Title RH-AMP INPUT MOD.			
Size	Number	Rev	
D	700-PCA082	F	
Date	12/28/94	Drawn by	F.O.
Filename	DOO057-F.S02	Sheet	2 of 2

Title: OUTPUT STAGE, CHANNEL PCB, AMPLIFIER, 1500W

RENKUS-HEINZ, Inc.	
Title: AC INPUT MODULE	
Size: D	Number: 700-PCA103
Date: 12/06/94	Drawn by: R.N.S.
Filename: D00653-H-501	Sheet: 1 of 1

RENKUS-HEINZ, Inc.		Title		POWER SUPPLY
		Size		Number
Date		12/06/94		Rev
Filename		D00053-K.S01		K
Sheet		1 of 1

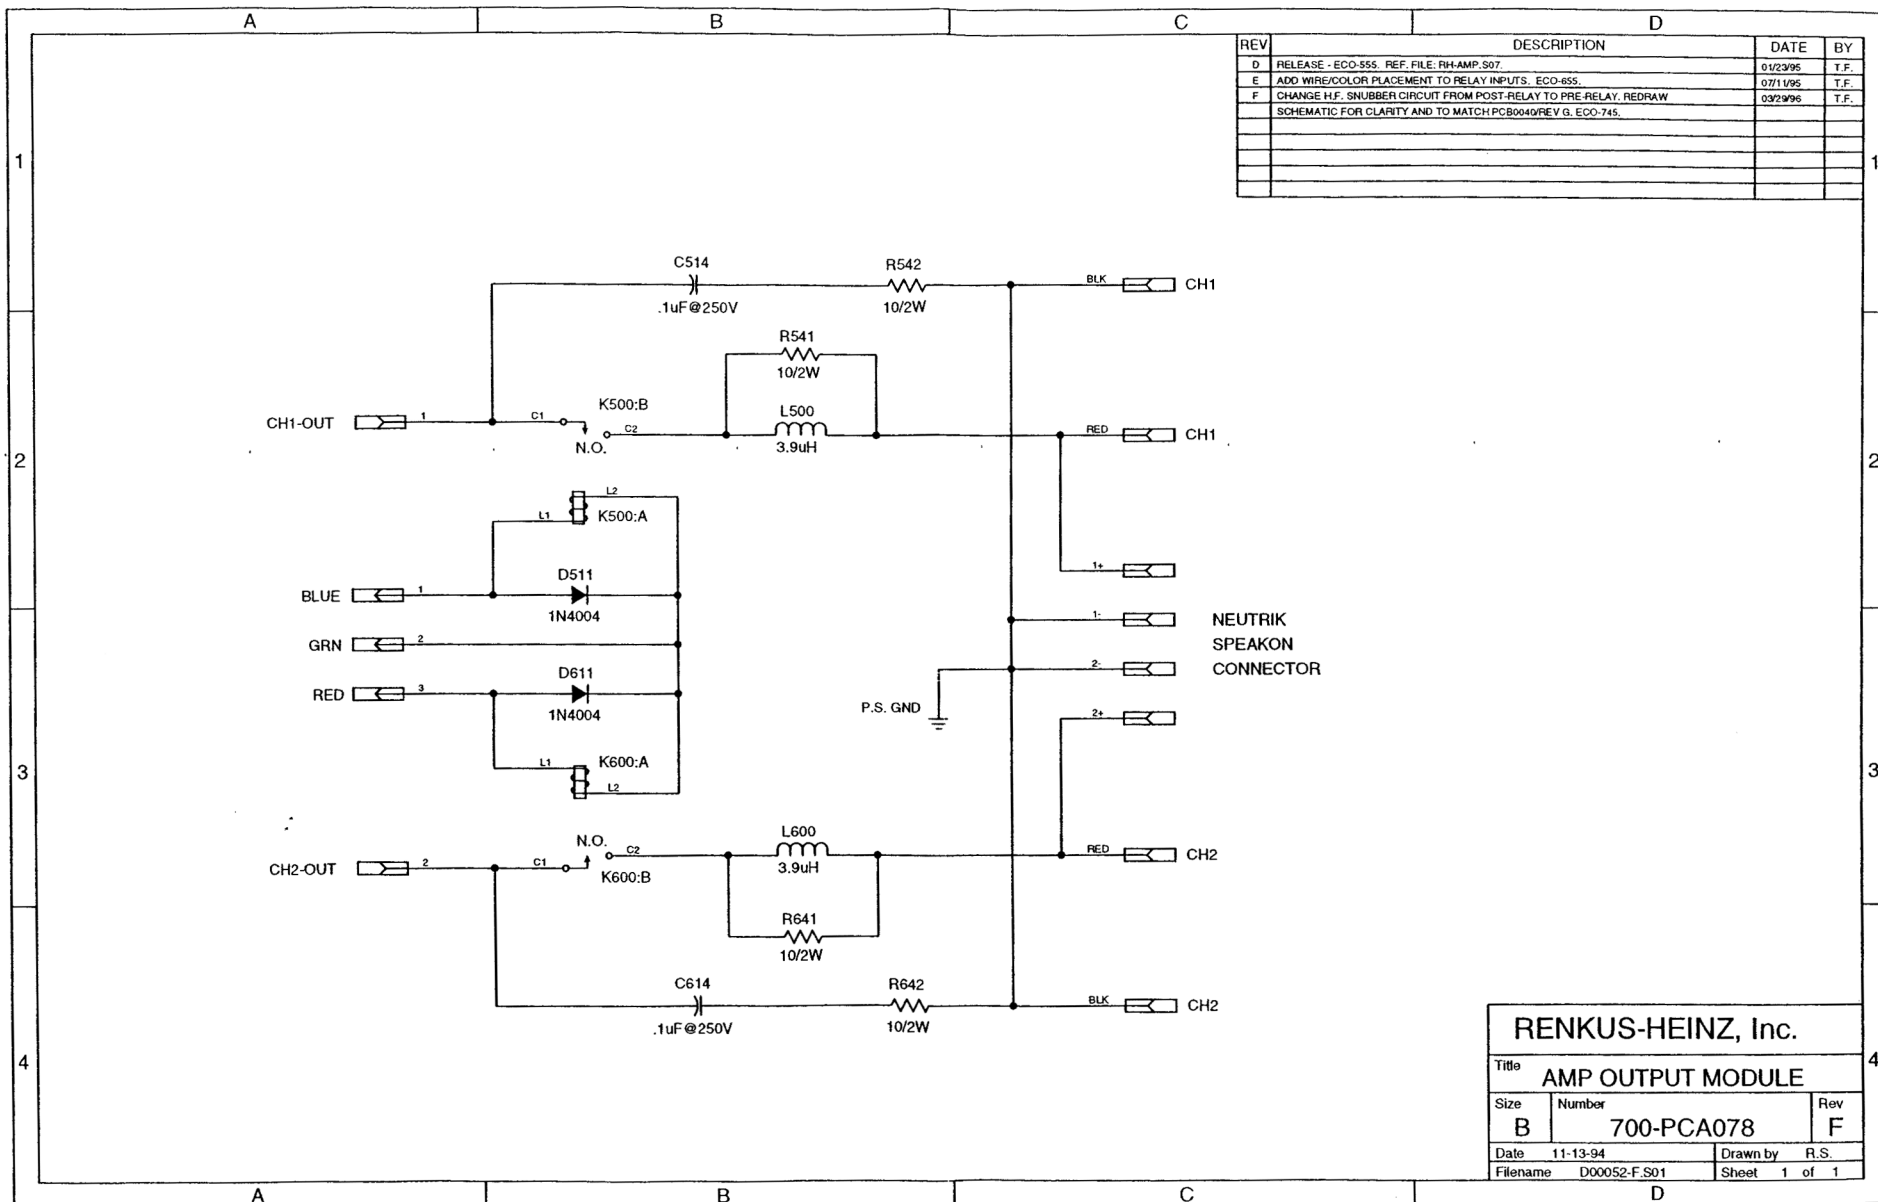
REV	DESCRIPTION	DATE	BY
D	NOTE: REF FILE: RH-AMP 506	01/10/95	T.F.
E	RELEASE: ECO-555	02/07/95	T.F.
F	ADD LOCATION CS2: 1uF - (REF: PCB ECO438) ECO-451		
G	CSO: WAS 100uF @ 160V - IS 100uF @ 100V. CORRECTION OF SCHEMATIC ONLY TO REFLECT ACTUAL PART BEING USED	07/06/95	T.F.
H	SEE ECO-493 FOR LIST OF CHANGES	09/08/95	T.F.
I	ADD CONNECTIONS FOR UNIVERSAL AC INPUT	10/04/95	R.N.S.
J	CORRECT INPUT LABELING TO CORRESPOND WITH PCB ADD C40: 1 @ 250V ECO 747.	09/27/95	T.F.

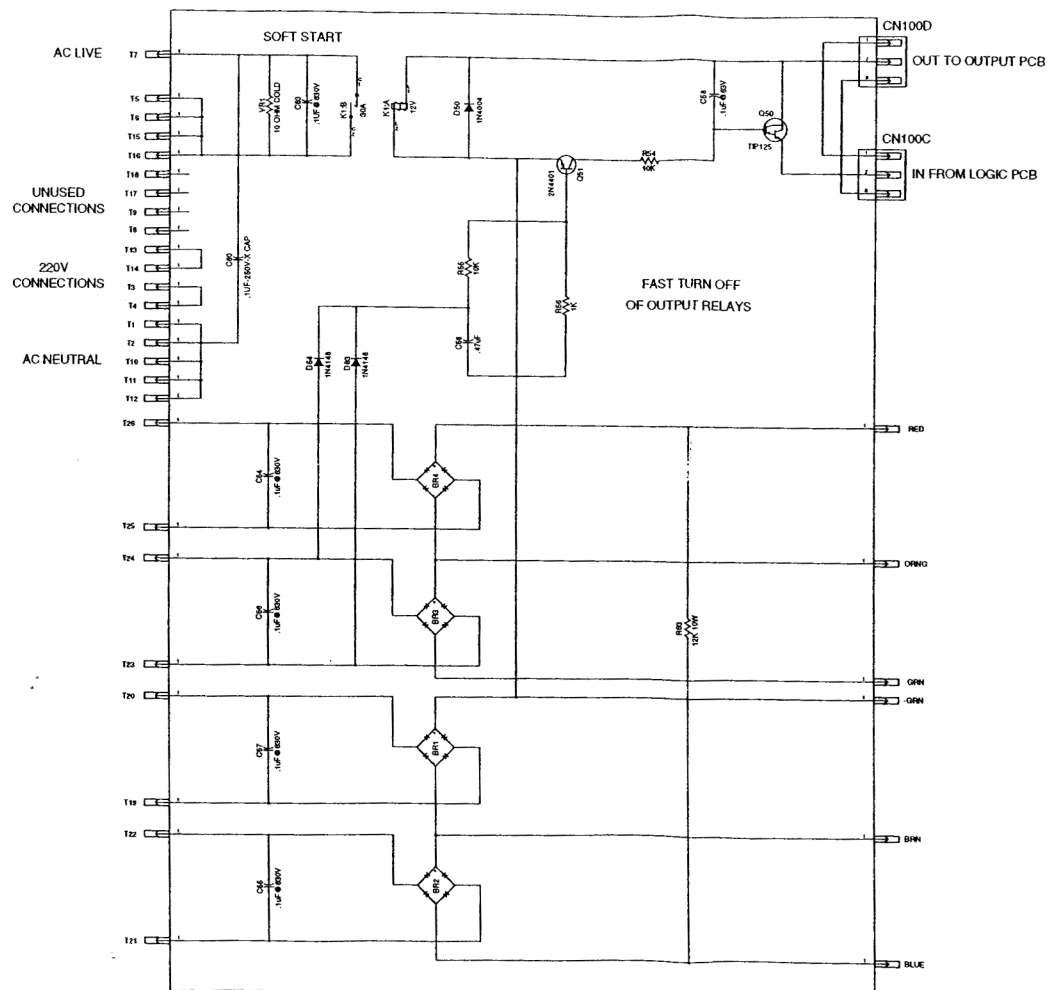
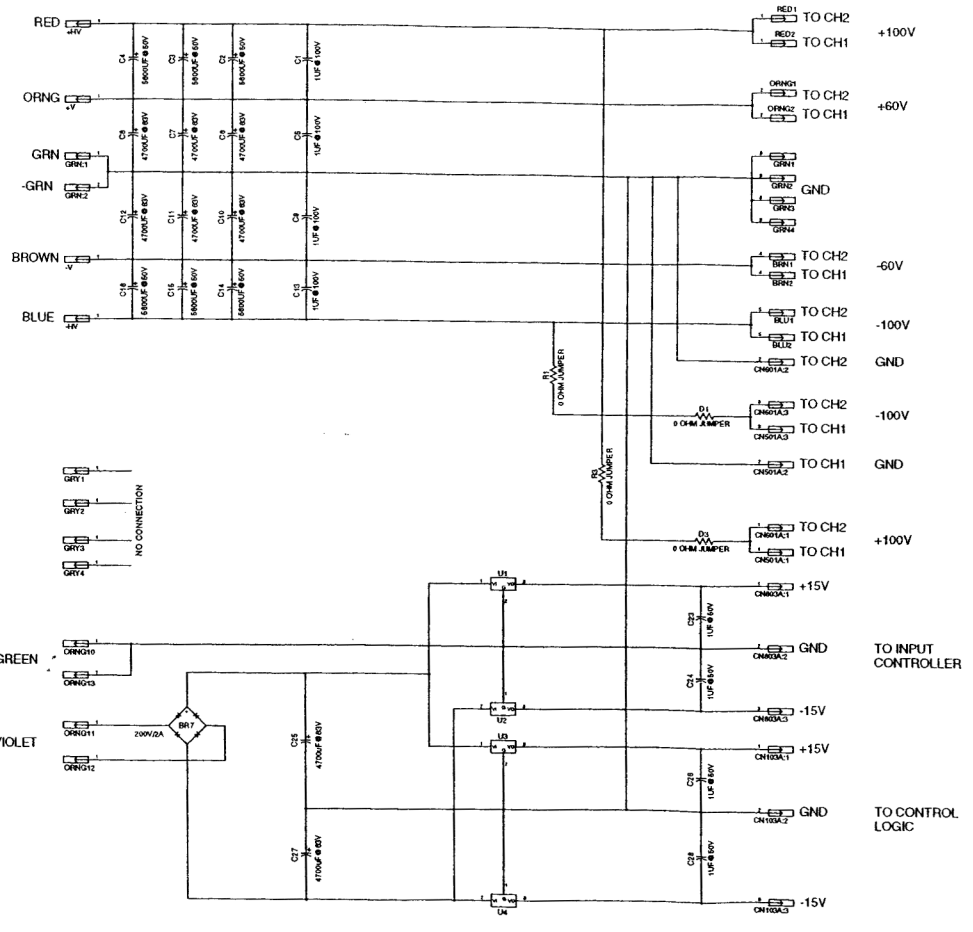
REV	DESCRIPTION	DATE	BY
D	NOTE: REF FILE: RHAMP.S08	01/15/95	T.F.
E	DEL IN/PMPS. ADD D1-2, R1-4, D1-4, C29 & C30.	02/09/95	R.N.S.
F	RELEASE REV E: ECO-555	02/24/95	T.F.
G	D1 - D4: REVERSE ALL. R1 & R3: WAS 1K - IS 2K. R2 & R4: WAS 1K - IS 1.21K.	07/07/95	T.F.
H	C29 & C30: WAS 47uF @ 100V - IS 22uF @ 250V (C29/C30 REF. SWITCHED). ECO-552		
I	BR7: WAS 1A - IS 2A. C1,C5,C9,C13: WAS 1uF @ 50V - IS 1uF @ 100V. C17,C20: WAS 1uF @ 100V - IS 2uF @ 100V. DEL 1200W REF. CLEANUP NOTATION. ECO-797.	04/01/95	T.F.
J	WAS JUMPER WIRE FROM CNS01-1 TO RED1 - IS TWO 0 OHM JUMPERS IN LOC. R3 & D3.	04/30/96	T.F.
K	WAS JUMPER WIRE FROM CNS01-3 TO BLU1 - IS TWO 0 OHM JUMPERS IN LOC. R1 & D1.	06/24/96	T.F.
	ECO-849		
	C27 & C28 WERE 12000uF/50V. ECO #3091.	6/23/00	GL
